11 December 2019

Ms. Melissa Anderson  
Major Projects  
NSW Department of Planning, Industry and Environment  
GPO Box 39  
SYDNEY NSW 2001

**RE: HANSON QUARRY EXPANSION – APPLICATION NO. 7293**

ATTACHMENT 2

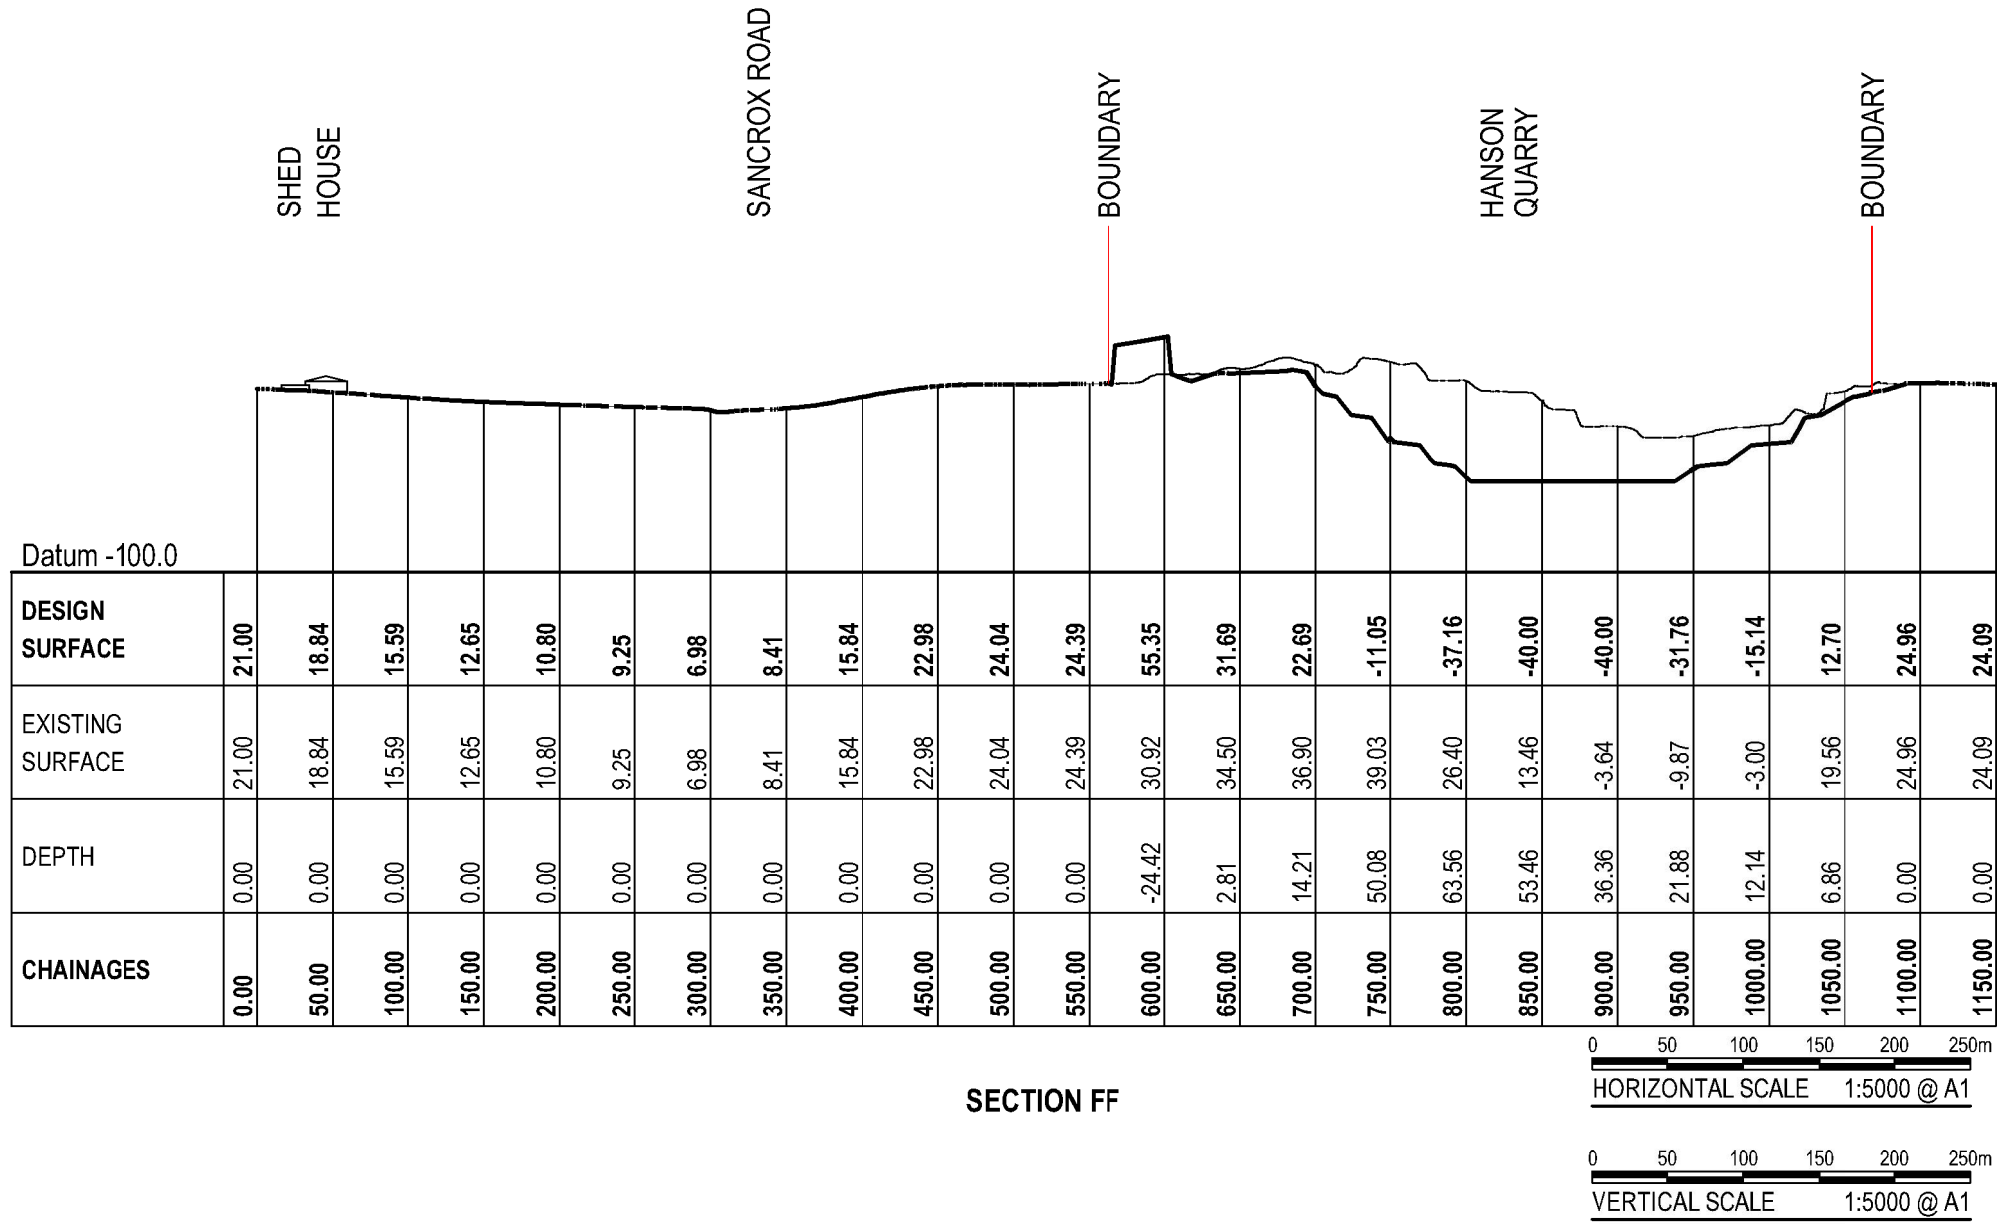
It is not clear from the documentation that the proposed bund wall on the Southern boundary of the quarry will stop the noise that will be generated. Attached at 2 are photos looking from our house towards the Southern edge of the quarry.

None of the photographs or analysis of visual amenity give us confidence that we will not see the quarry operations in the future. Attached at 2 are the photos from our house and we would prefer to not have to see any future quarry operations from our house.
